CLAY & MONTGOMERY

AS OF 09/18/2019

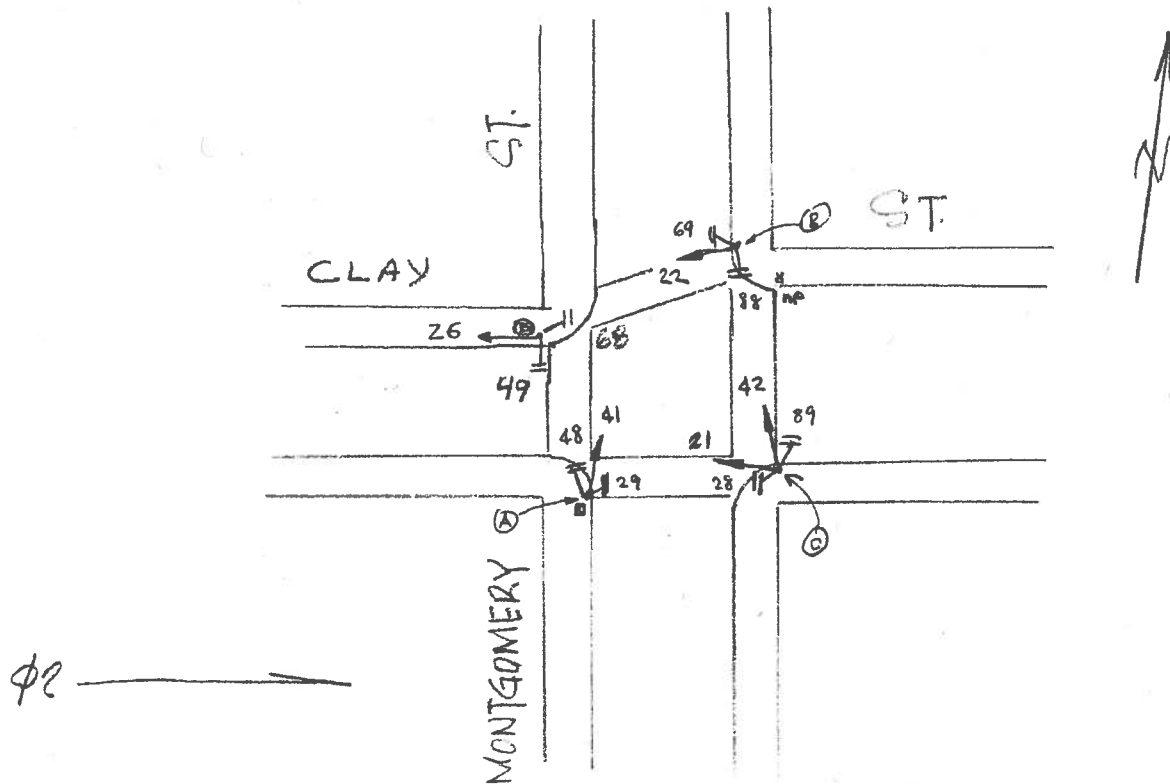
per. SRC 2018-417, upgrade signals 21, 22, 41, 42 to 12" A.kim
